**Notice of specification change of MCCBs**

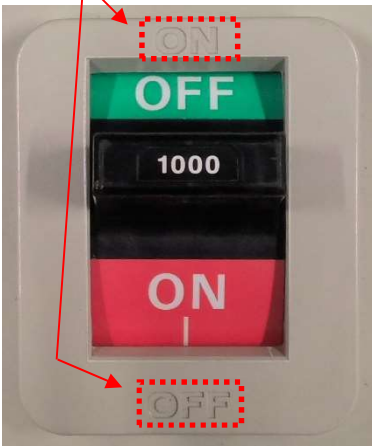
Erase the "ON/OFF" engraving on the body cover.

Types	Before	After
E.g.)NF1000-SEW 3P 	<p><u>"ON/OFF" engraved</u></p> 	<p><u>No "ON/OFF" engraved</u></p>
